ADDENDUM NO. 1
to
CONTRACT DOCUMENTS

for
HVAC RENOVATIONS TO PRINCETON HIGH SCHOOL
located at 151 Moore Street, Princeton, NJ 08540

FVHD PROJECT NO. 5516E

Issued: February 24, 2026

Drawing Number
A201

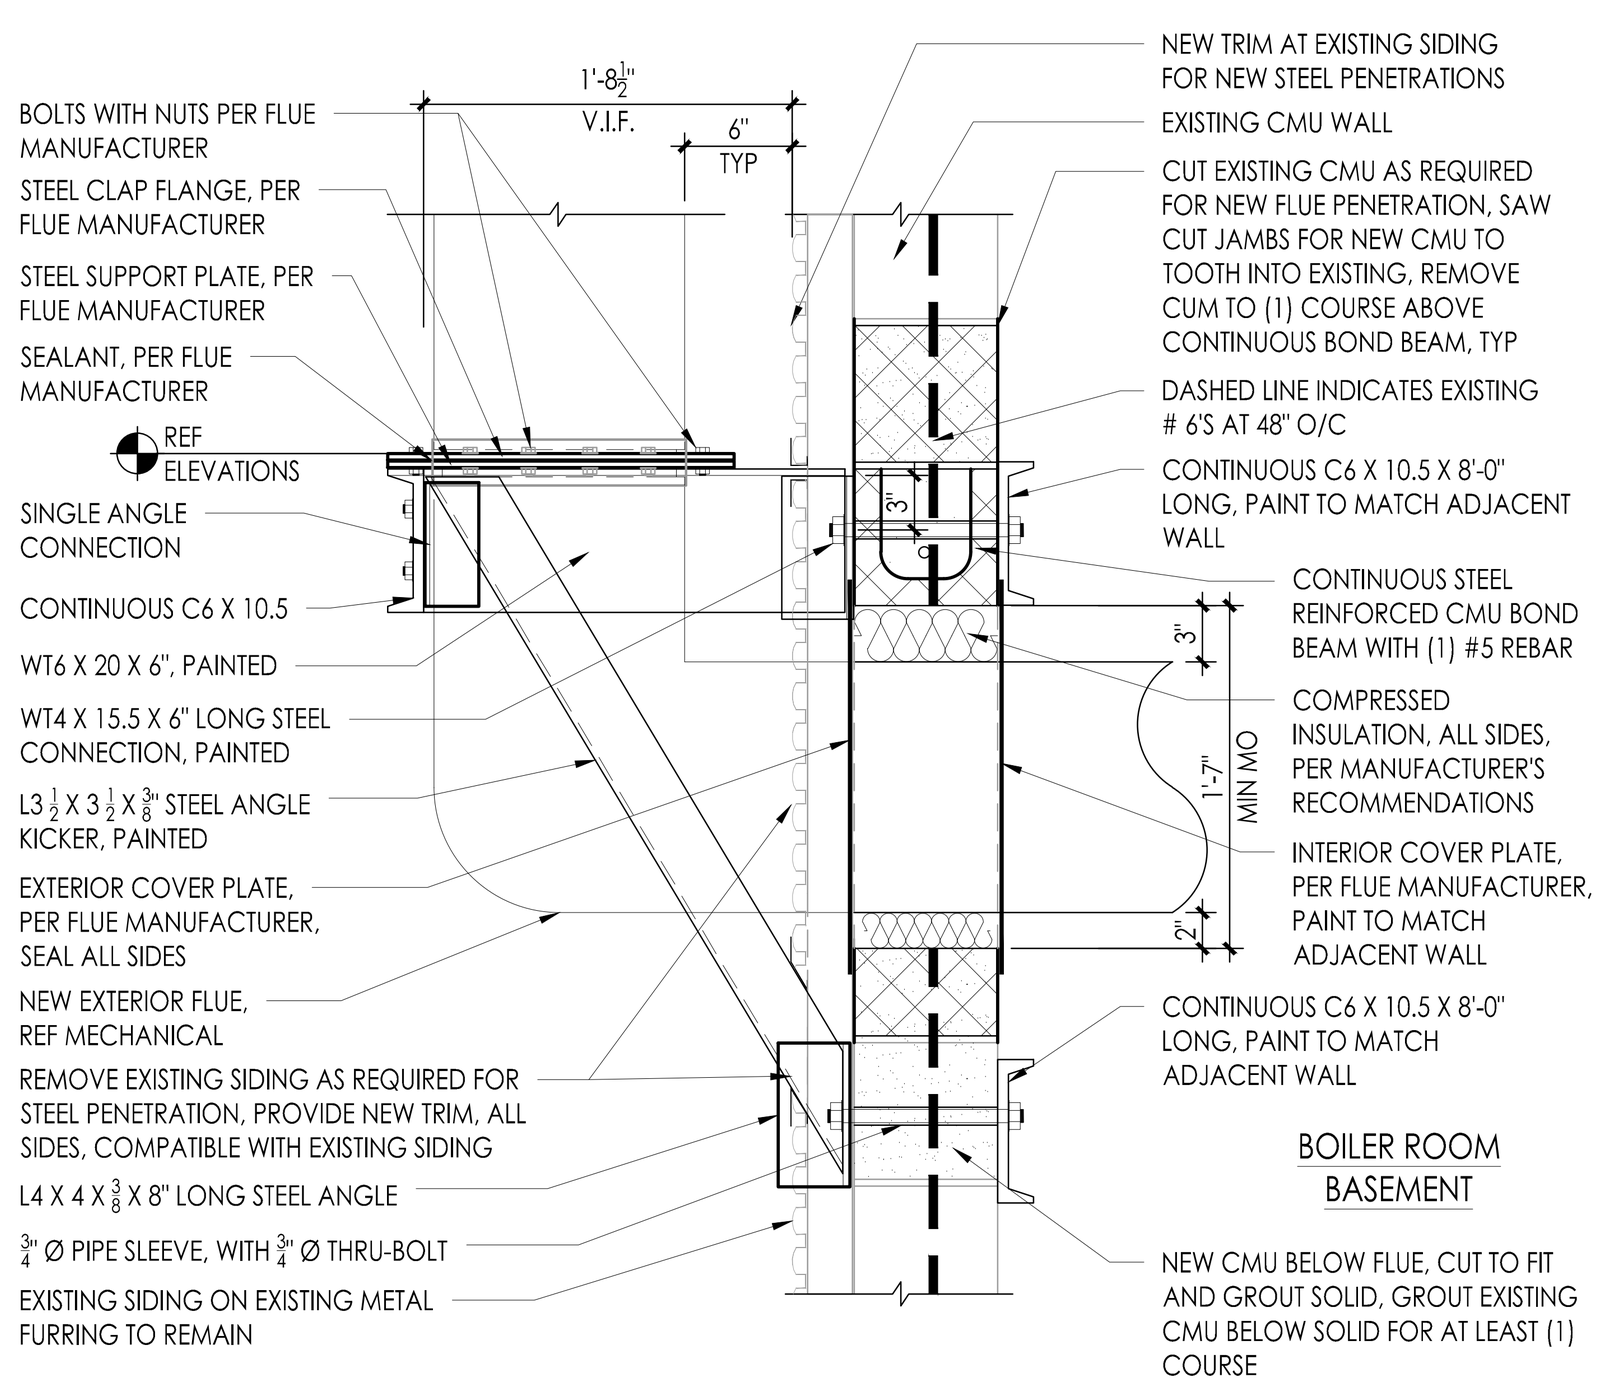
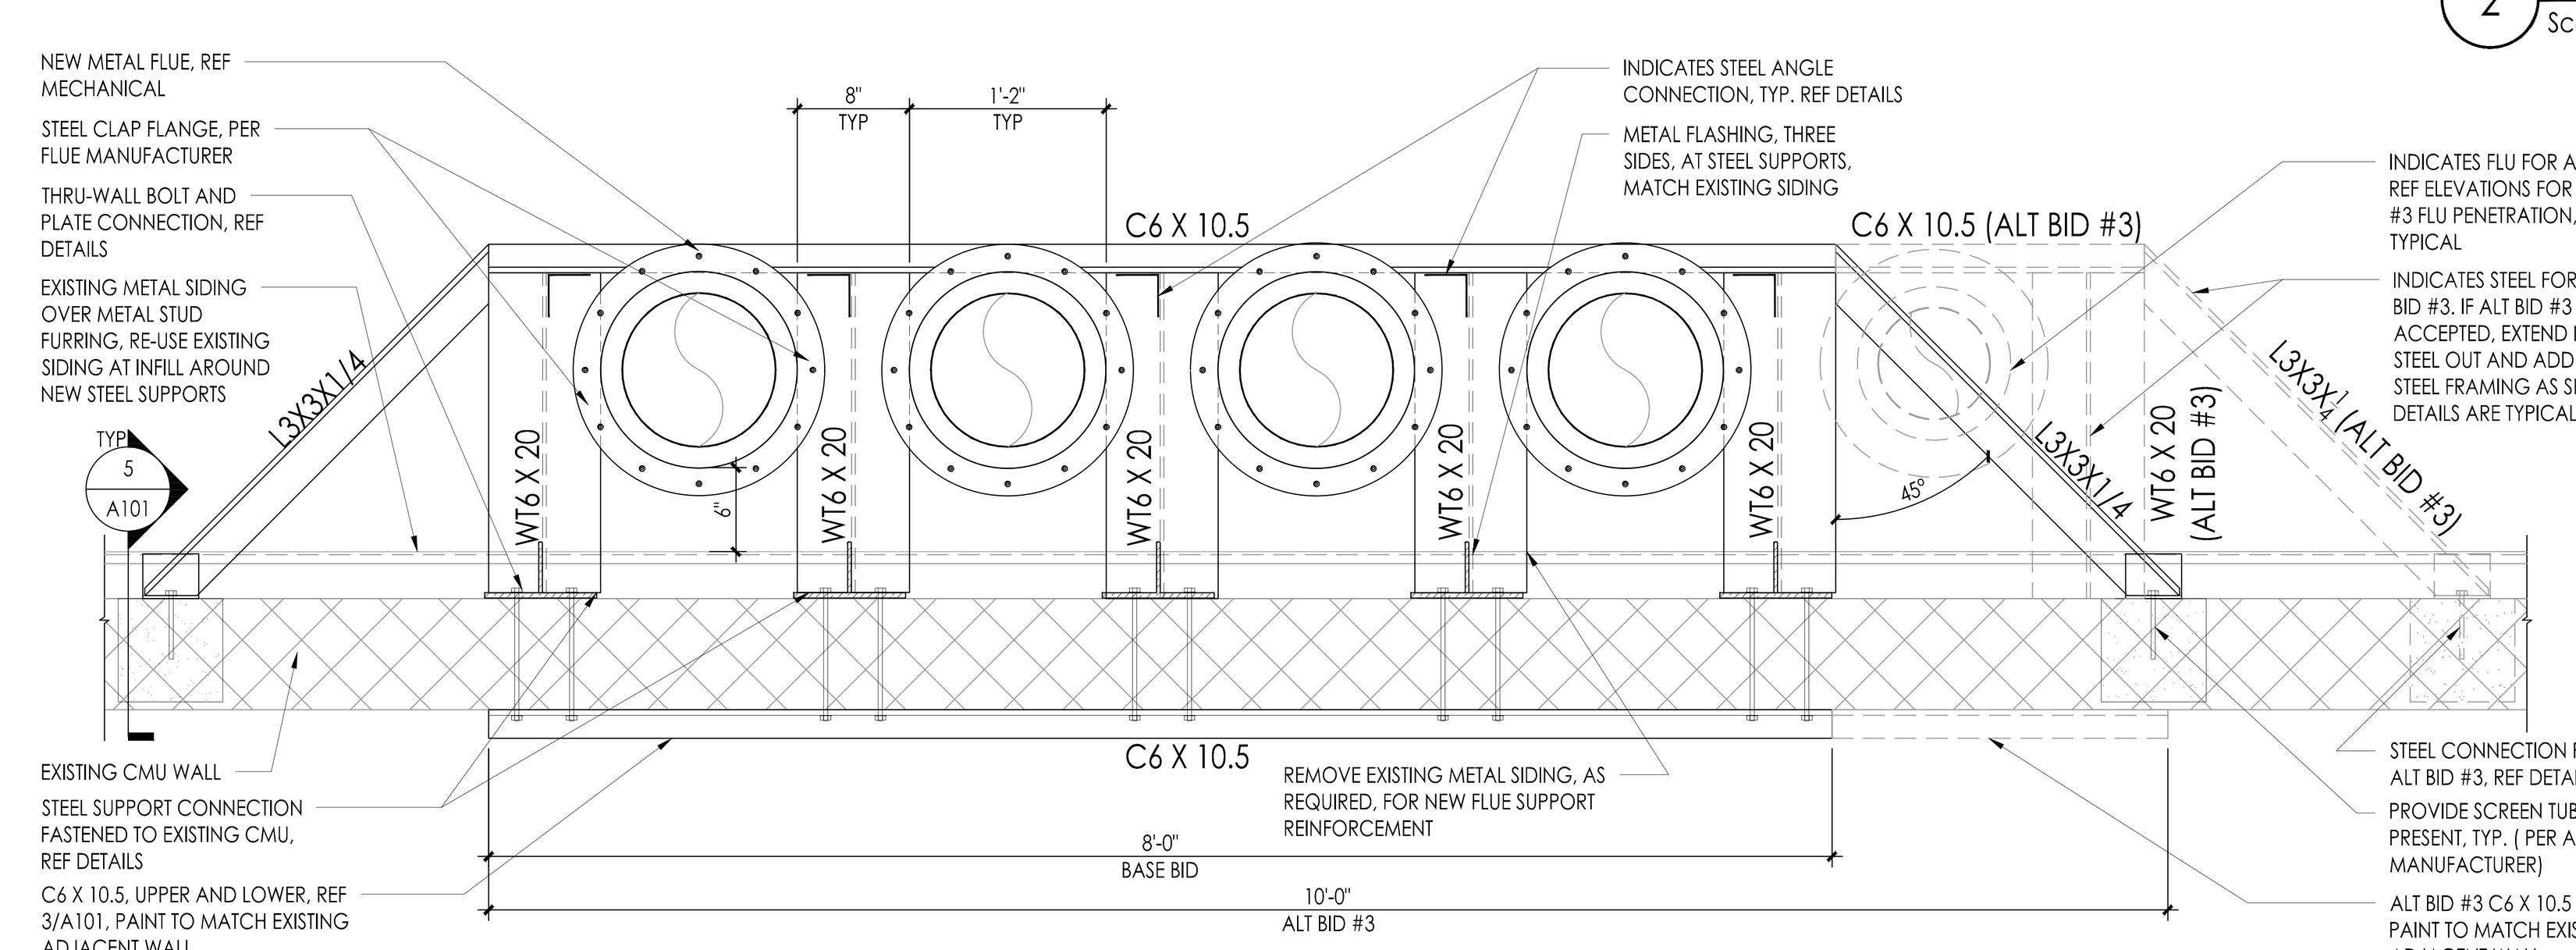
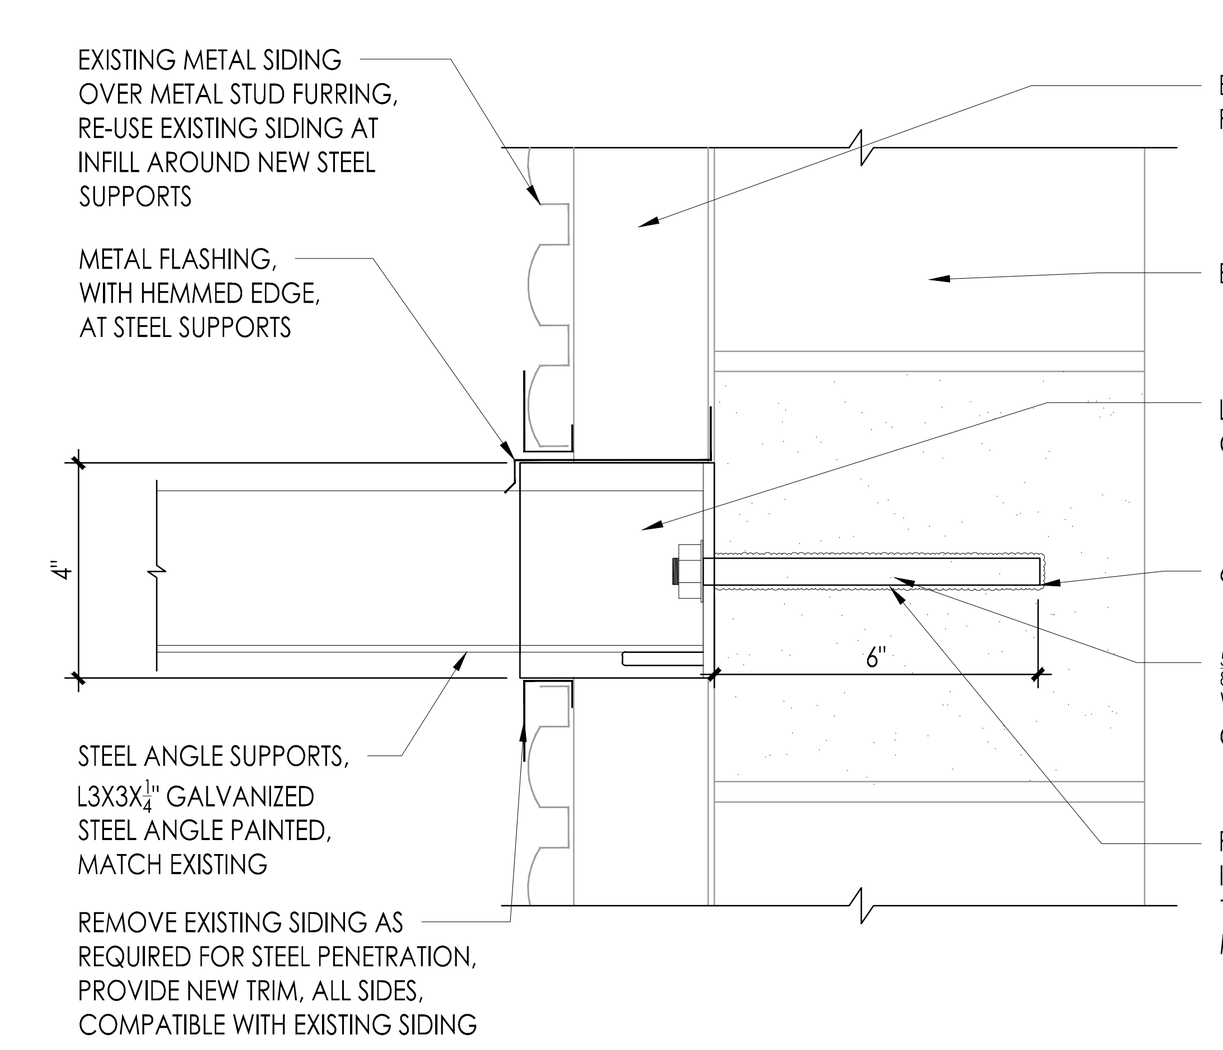
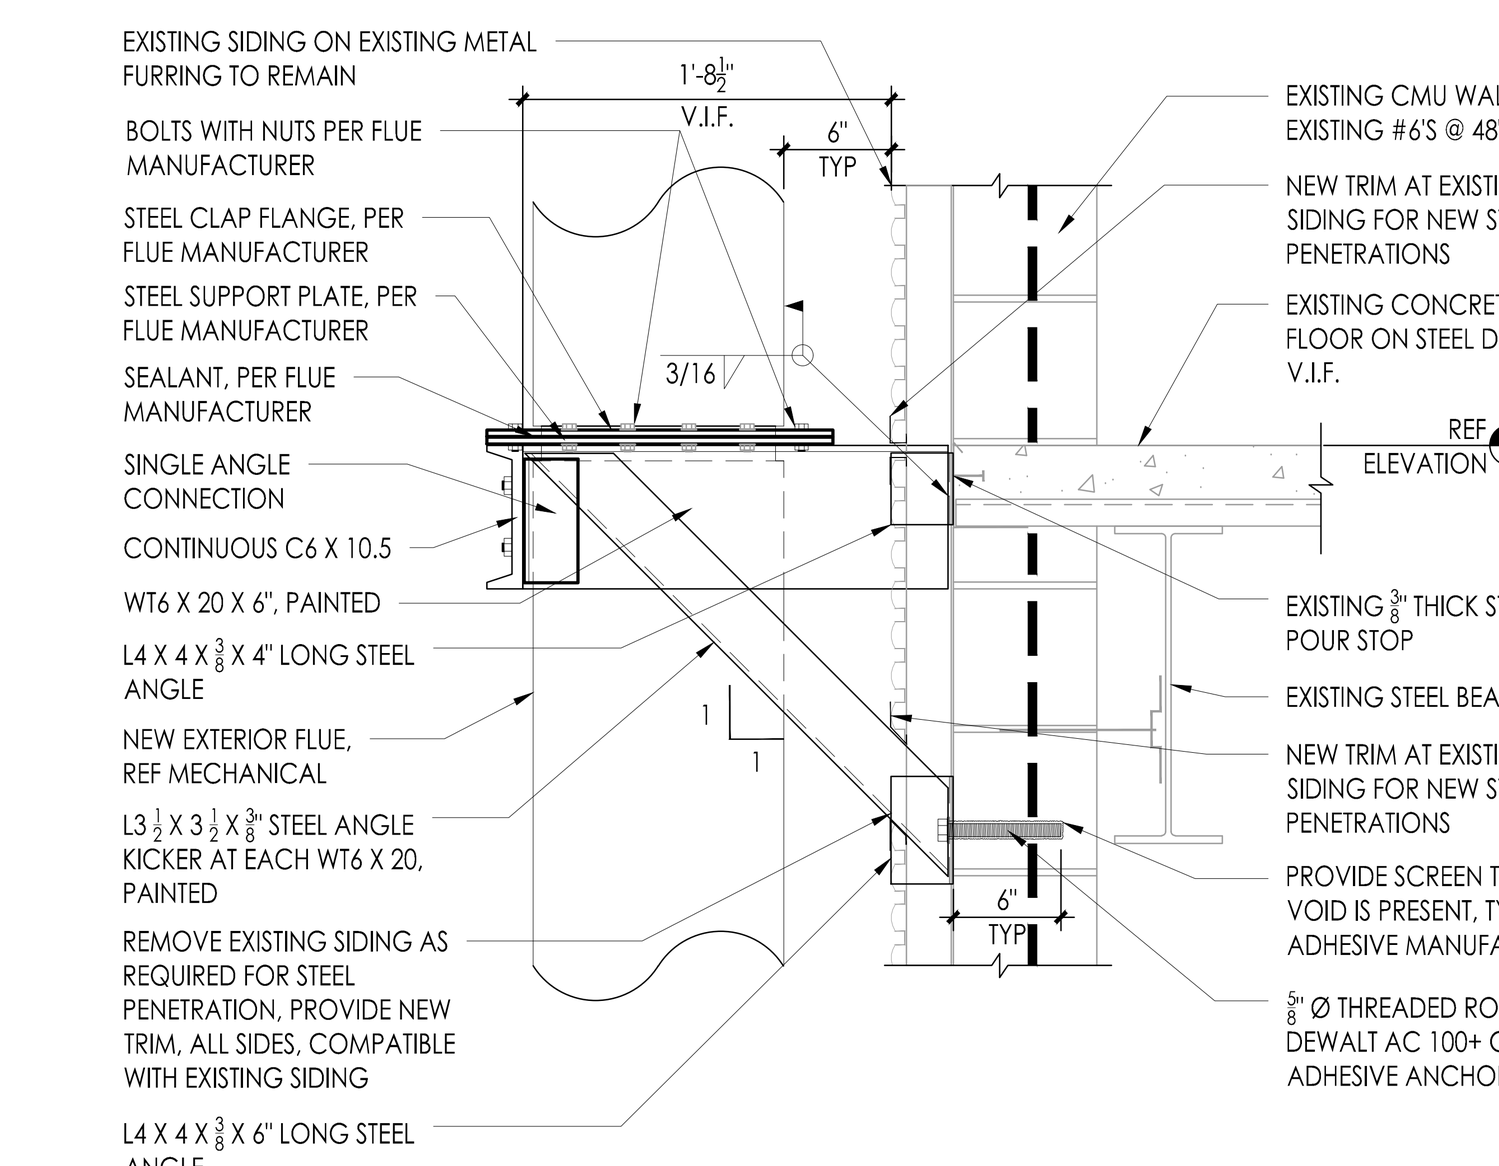
5. Question: On Drawing A201, Notes (3)- 9 times, (4) - 1 time, and (10) -5 times, all refer to 11/A201, there is no 11 / A201, please advise. Also are we to assume (1) angle frame per occurrence?

Response: 10/A201 should be 6/A201, and 11/A201 should be 4/A201. (Refer to the updated Drawing). The steel angle RTU support size is referenced in the steel notes on Detail 6/A201.
